**BCA ASSESSMENT REPORT -
SCHEMATIC DESIGN**

**PROJECT: Goulburn Hospital & Health
Services Redevelopment**

PREPARED FOR: TSA Management

Revision 1

Lower Ground

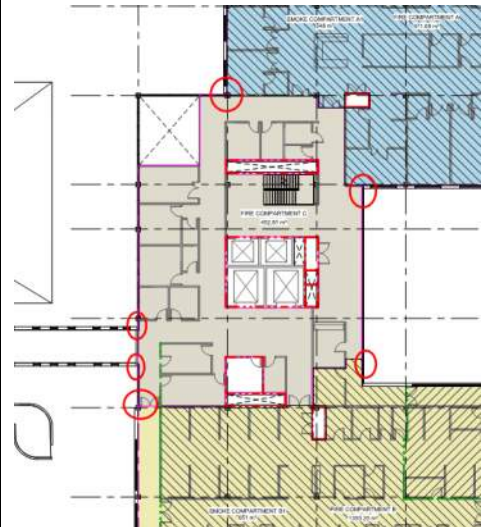
Performance Solution:

The following protection of openings between different compartments will be rationalised in the fire engineering report;

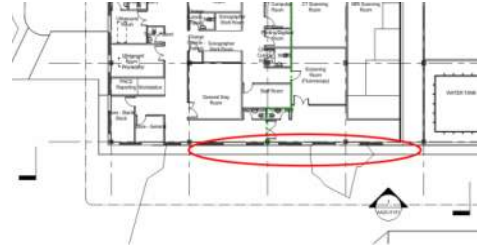
The central Plant room on Level 3 requires access to the fire stairs, refer below.

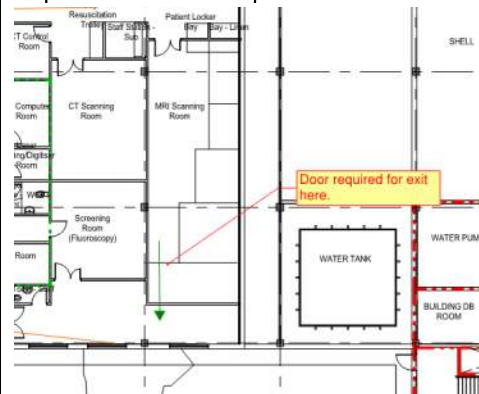
An additional exit to open space is required to southern side lower ground floor medical imaging.
